10540 GREENWOOD AVE N
DESIGN REVIEW BOARD
2ND RECOMMENDATION MEETING
18th June 2018
DPD Project: #3022986

DESIGN REVIEW MEETING (SUPPLEMENTAL)

SDCI Project #: 3022986
 Address: 10540 Greenwood Ave. N
 Seattle, WA 98133
 Parcel #: 8911000340
 Project Type: Mixed-Use
 Project Description:

ELEVATION: WEST

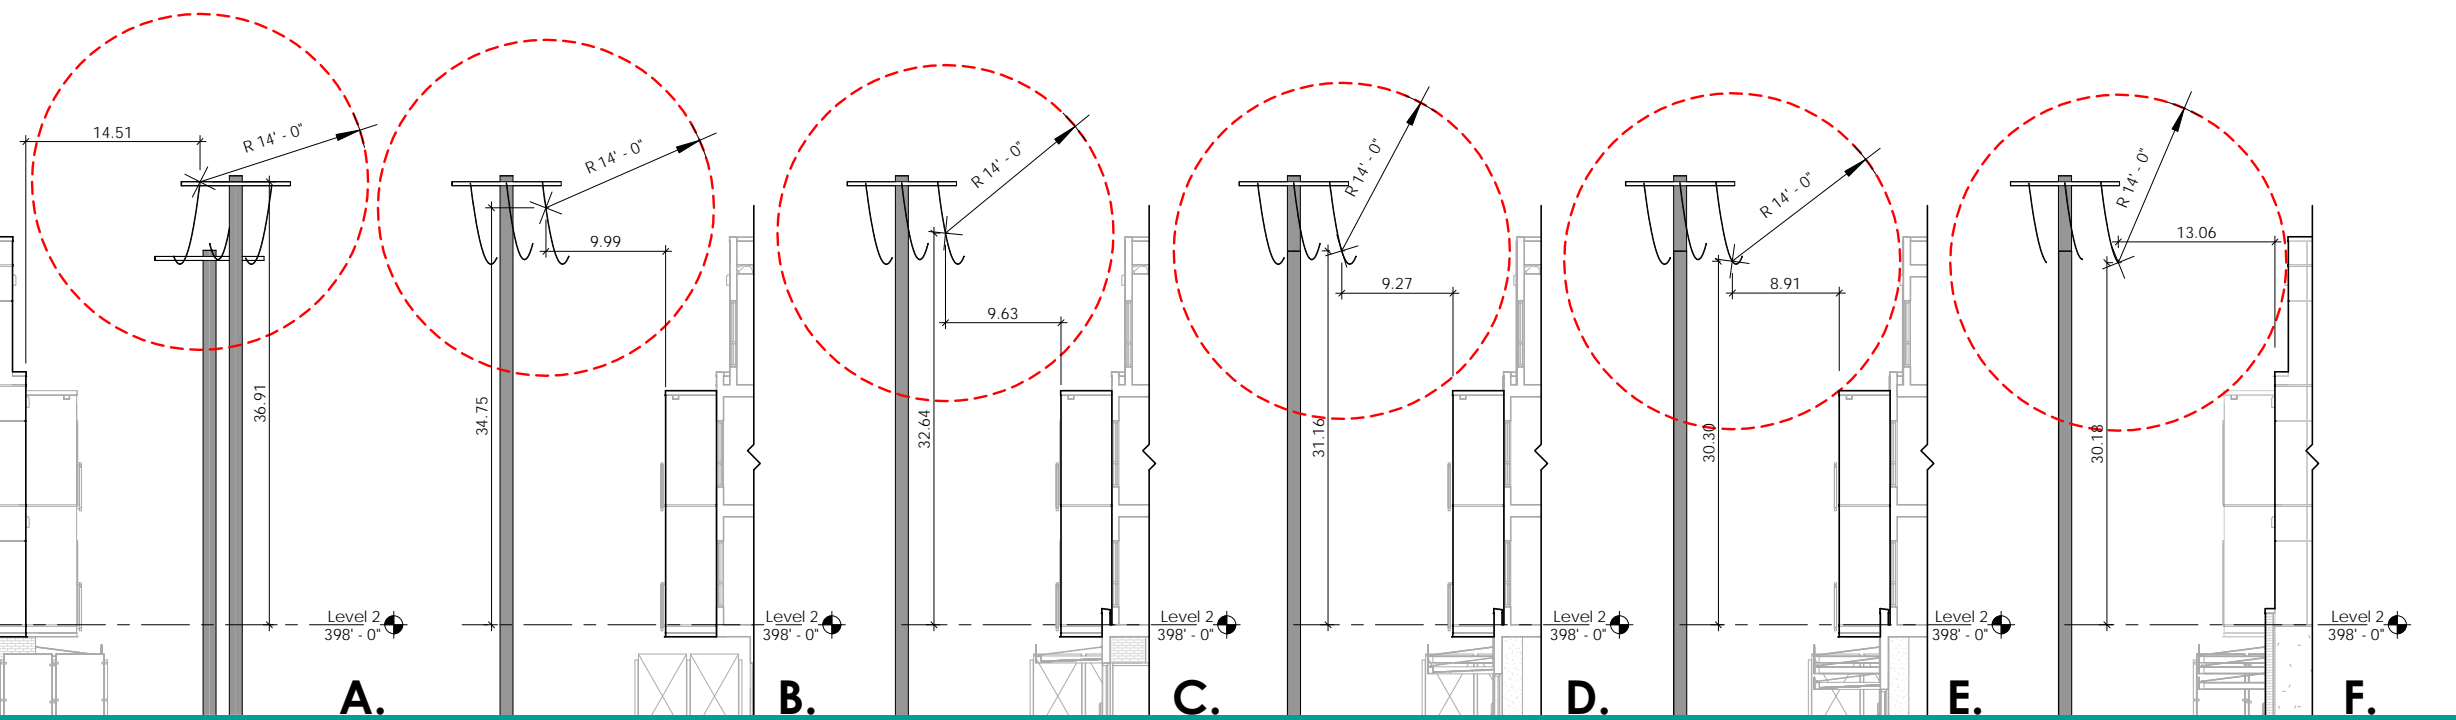
<p>2. Façade Composition</p> <p>a. West Elevation</p> <ul style="list-style-type: none"> i. The Board discussed the bays, commenting that the three southern bays created a regular rhythm however the differing width of the northern bay should be resolved. (DC2-B-1. Façade Composition). ii. In addition, the Board provided guidance to increase the height of the bays with the goal of further distinguishing the bays from the foreground massing and further strengthening the expression of the bays. (DC2-B-1. Façade Composition). iii. The Board was supportive of the channel along the east façade, however, they expressed some concern that aligning the channel and venting could be problematic at time of construction. The board provided guidance to further study this detail and confirm the constructability and location of this detail. (DC2-B-1. Façade Composition, PL2-C-2. Design Integration). iv. The Board expressed concern with the slight modulation along the 4th and 5th stories which accommodated the existing powerline without tying back to a design logic. The Board provided guidance to revise these floors to create a consistent setback along Greenwood Avenue. (DC2-B-1. Façade Composition). <p>b. North Elevation</p> <ul style="list-style-type: none"> i. The Board discussed the setback along the northern edge. At EDG the Board provided guidance to demonstrate the relationship of the proposed lightwell to the lightwell of the northern building. At Recommendation the board reiterated their direction to study this relationship and illustrate this adjacency condition at the next meeting. (DC2-B-1. Façade Composition). <p>c. South Elevation</p> <ul style="list-style-type: none"> i. The Board discussed the blank wall condition commenting that the large setback and channel recesses provided adequate relief along this part wall condition. (DC2-B-1. Façade Composition). <p>d. East Elevation</p> <ul style="list-style-type: none"> i. The Board supported the regular rhythm created by the bay expression which reduced the height, bulk, and scale along this zone transition. However, sections and a plan view study should be provided at the next meeting illustrating the relationship to adjacent neighbors, as well as, clarifying the depth of the rear open space and grade change. (DC2-B-1. Façade Composition, CS2-D-5. Respect for Adjacent Sites, CS2-D-4. Massing Choices). 	<p>Response:</p> <ul style="list-style-type: none"> a. <ul style="list-style-type: none"> i. All bays are now equal due to the eastern shift away from the mandatory high voltage clearance. (9, 11-13, 16, 29) ii. The bay height can't increase due to the power lines. In fact, they decreased in height slightly. (9, 16-19, 28) iii. The venting is located to either side of the channel with a false cover over the channel for visual effects. An exploded axonometric diagram has been added to convey this detail in the Elevations section. (16) iv. The top setback is now aligned along a single grid line, pursuant to the Board's guidance. (13, 16, 19, 28) b. <ul style="list-style-type: none"> i. The requested information has been included in the Neighbor Relations section. (20 21) c. <ul style="list-style-type: none"> i. The south elevation demonstrates the setback and channel recesses that provide adequate relief, as stated by the Board. (19) d. <ul style="list-style-type: none"> i. Sections and a plan have been added as requested. Additionally, an elevation of the fence as seen by the neighbors have been included. (18, 20 21, 28 29)

NOTE: The West facade was shifted East, allowing the North bay to match the width of the other three bays. The maximum bay height is limited by the Southernmost bay, see Section E.

1st LEVEL

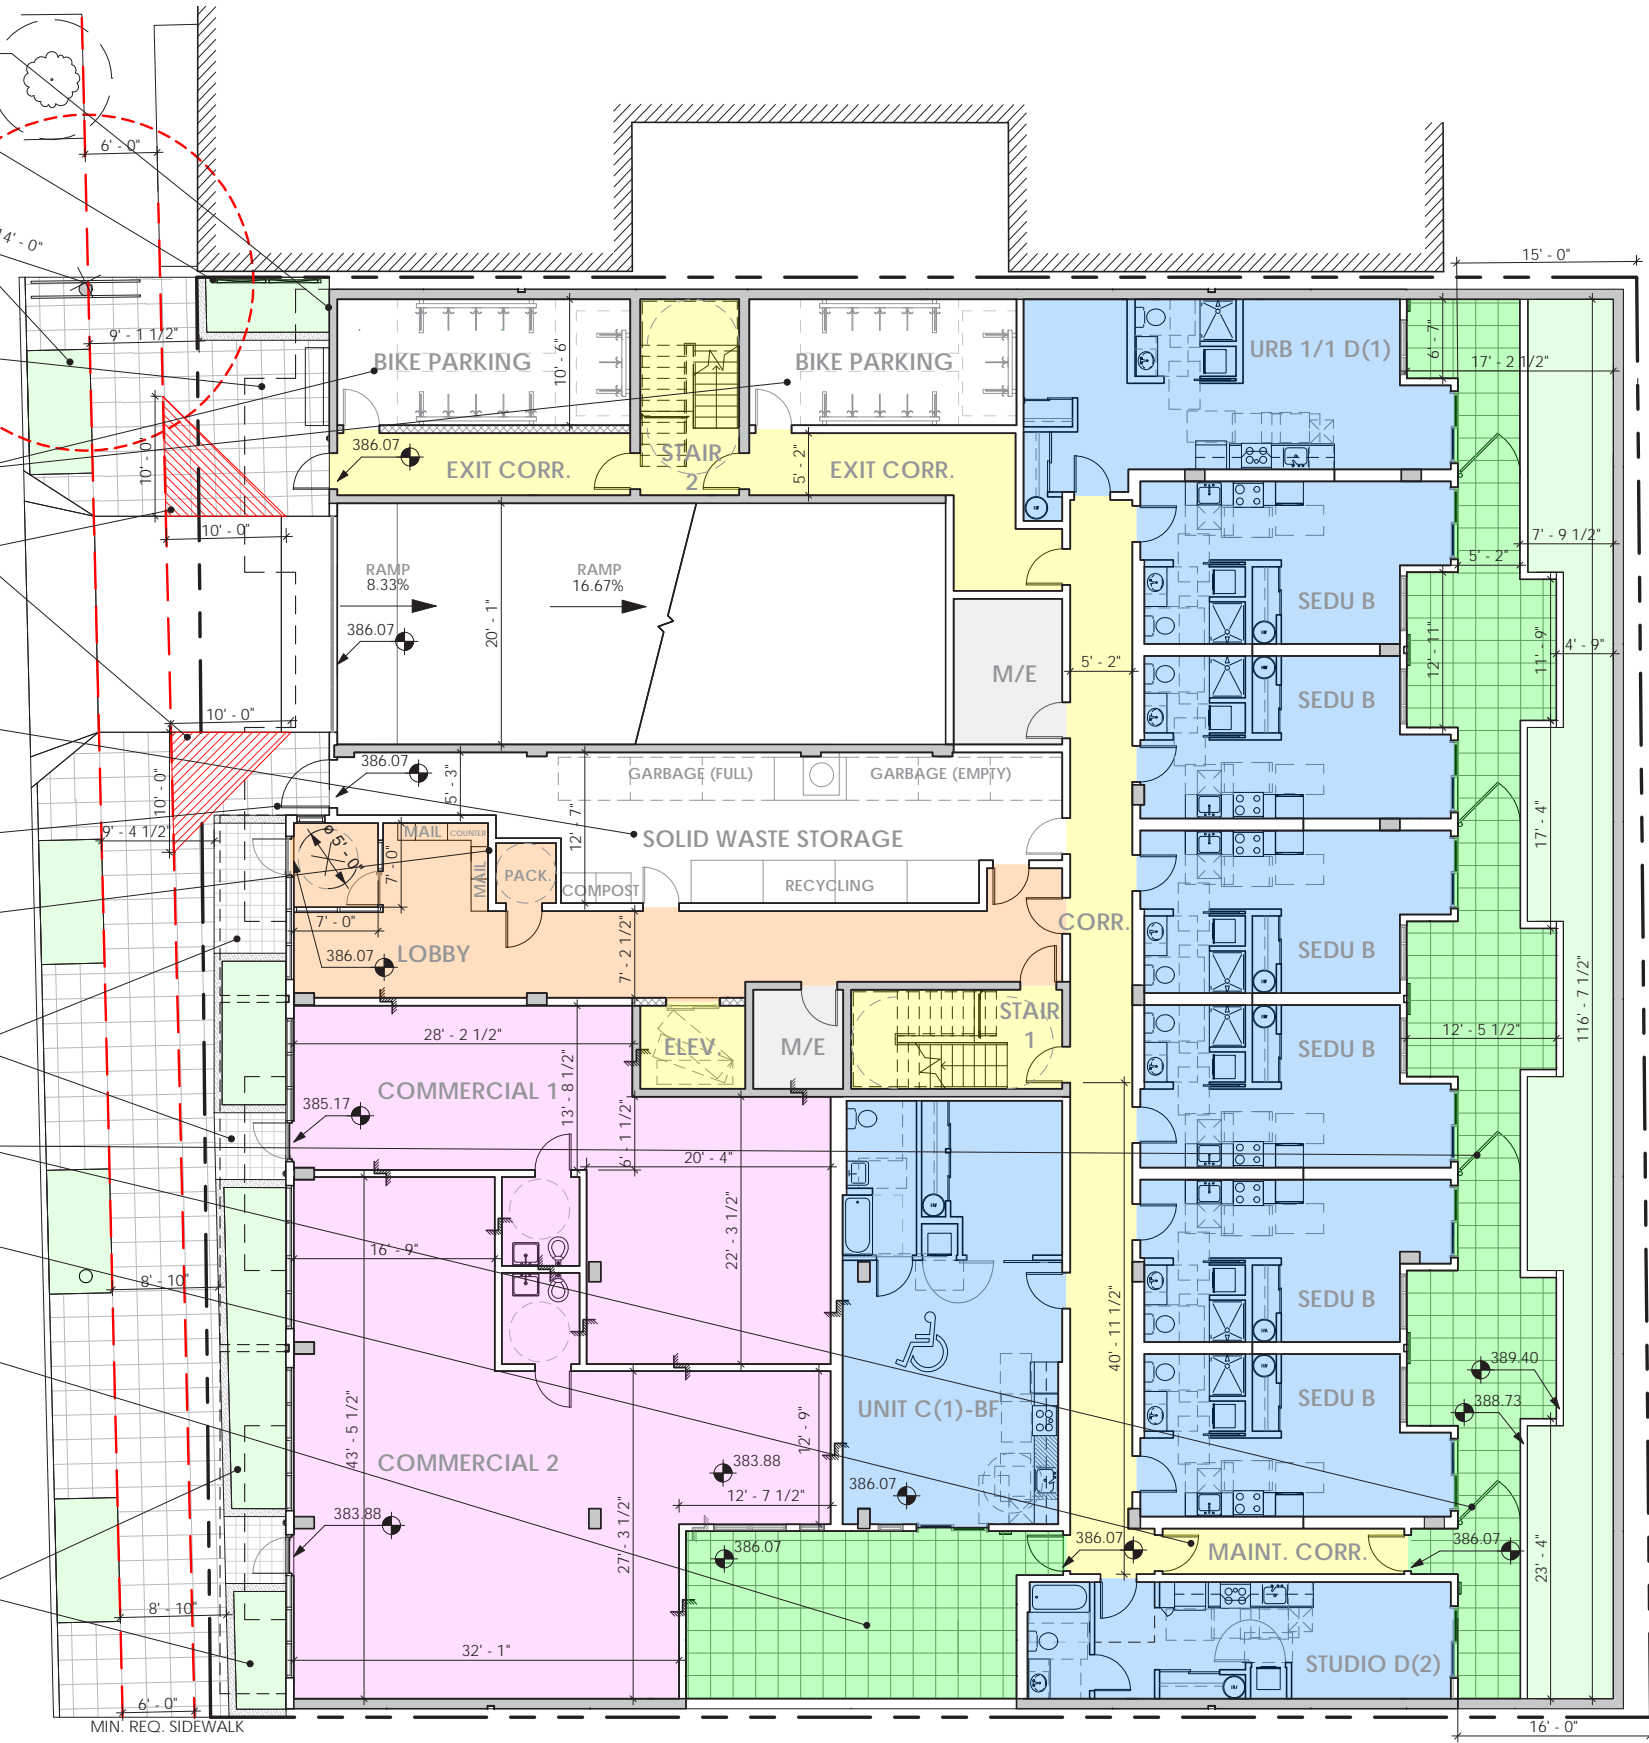
<p>3. Street-level Composition and Interior Programming</p> <p>The Board discussed the façade composition and the relationship to interior programming along the street-level and provided the following guidance:</p> <p>a. The Board was concerned with the unnecessary fragmenting and interruption of the street-wall created at the ground floor by recessing the corridor entry at the northern most corner. The Board provided guidance to resolve this configuration at the northern most corner by bumping out the corridor to be flush with the street-wall, as well as, exploring one door rather than two at this location with the goal of creating a more continuous street-wall, avoiding an unsafe condition, and cleaning up the entry/exit points. (DC2-B-1. Façade Composition, PL-B Safety and Security).</p> <p>b. The board was concerned with the location and circulation of trash, specifically commenting on the location of the trash door adjacent to the main residential entry, width of the corridor, and placement of the exit door which created an awkward turning condition for the trash circulation. The Board provided guidance to pull back the service/corridor entry door to place greater emphasis on the main residential entry, explore treating the service/corridor door with similar coloring to the brick wall, and placing the door along the street. (DC2-B-1. Façade Composition, DC1-C-4. Service Uses).</p> <p>c. Related to the location of this door, the Board commented that by pulling the service/corridor door further back, the need for a sight triangle departure may be avoided. (DC1-C Parking and Service Uses).</p> <p>d. In addition, pulling back the service/corridor door the main entry could potentially have a glassy corner distinguishing this entry from the retail bays. The Board also provided guidance to strengthen the ensemble of entry components including signage, lighting, and landscaping, as well as, creating a more logical terminus for the awning above the residential entry.(PL2-C-1. Loctions and Coverage, PL3-A. Entries).</p>	<p>Response:</p> <p>a. The northernmost corner is now flush with the garage door. Service entries are on a recessed plane from the main residential lobby and commercial entries; clearly distinguishing access by use and creating a small outdoor gathering space. (11, 29)</p> <p>b. Bicycle parking has been moved north, next to stair 2, to create a more regular garage area, less congestion at the entry, and was pulled back. The garbage chute has been moved to better facilitate trash circulation. There is now only one door. (11)</p> <p>c. The service/corridor door have been pulled back, as guided. There is no longer a need for the previously requested departure. (11)</p> <p>d. The main residential entrance has a glassy corner, per Board guidance. The signage has been improved to be more integrated into the design. The canopy terminates at the setback edge. The canopy heights and storefront paint change creates hierarchy. (11 16 29)</p>

Setback helps distinguish proposed project from neighboring mass (DC2-A.2).

Greenscreen at neighbor's edge (CS1-D.1).

Planters match neighbor's for continuity of the sidewalk (CS1-D.2).

Recess is now flush to create an open, public gathering space. (CS2-B.3).

Bike parking moved to relieve congestion; amenity split level removed (PL4-A | B).

Northern setback is now flush, providing the site triangle clearance.

Garbage storage closer to perimeter (DC1-C).

Service corridor pulled back, creates glassy corner (PL3-A).

Package room/ mail area added.

ROOF LEVEL 2

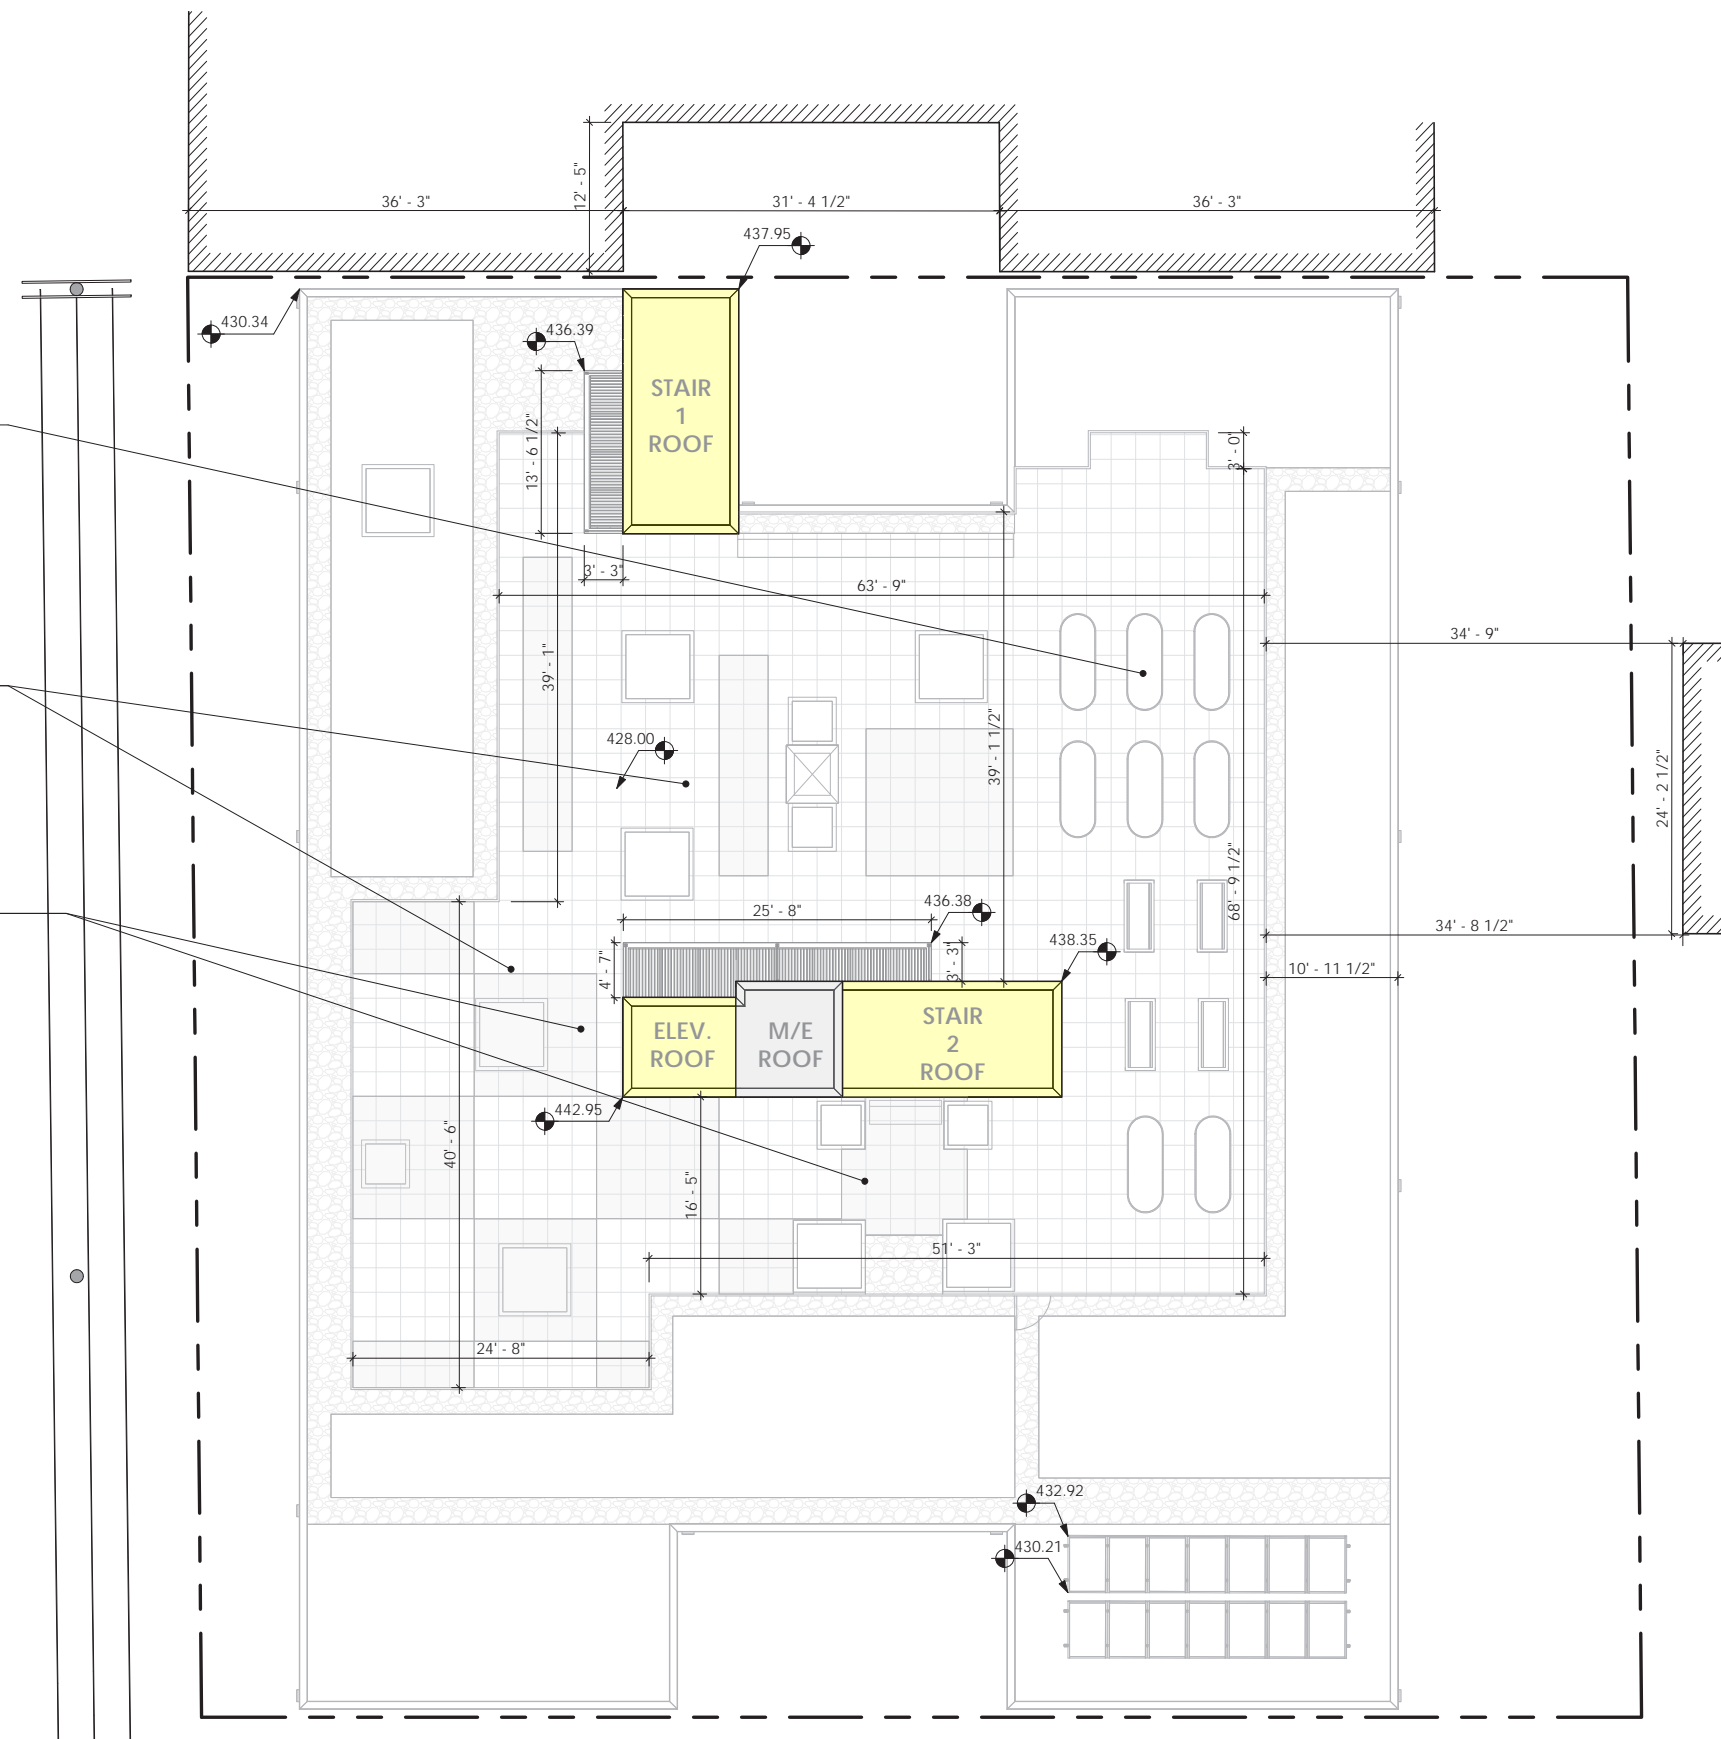
<p>4. Landscaping</p> <p>The Board discussed the proposed landscape plan, commenting that the relationship of the green space to the interior uses was unclear. Specifically, The Board would like the following provided at the next meeting:</p> <p>a. Dimensioned landscape plan. (3-B-1. Meeting User Needs).</p> <p>b. Section of the landscape areas (north, south, and east)(C3-A-1. Interior/Exterior Fit).</p> <p>c. Clarification of access, maintenance, and users of each space. Specifically, the Board expressed concern for the southern amenity space which lacked clarification on whether the space was intended to be used by commercial, residential, or shared. (CS-B-1. Meeting User Needs, DC3-A-1. Interior/Exterior Fit).</p> <p>d. In addition, the Board commented that the eastern landscape area should provide a mix of plants which include evergreens for year-round landscaping. (DC4-D-1. Choice of Plant Materials, CS2-D-5. Respect for Adjacent Sites).</p> <p>e. The Board also commented location activity areas on the roof should be pulled away from the single-family along along the eastern edge. (CS2-D-5. Respect for Adjacent Sites).</p>	<p>Response:</p> <p>a. The requested information is located in the Plans section. (12 13)</p> <p>b. The requested information is located in the Elevations section. (17, 19, 21)</p> <p>c. Clarifying notes have been added to the floor plans. The courtyard in question is used by the interior unit and accessed for maintenance from the corridor. (11, 31)</p> <p>d. The landscape includes a variety of plants, see Landscaping. (22)</p> <p>e. The activity area on the roof is located on the western portion of the site, the east is reserved for gardening. (15, 30)</p>

Eastern portion of the roof amenity area is reserved for gardening and other quiet, day-time activities.

Western | Northern portions of the roof amenity area serves as the active area (CS2-D).
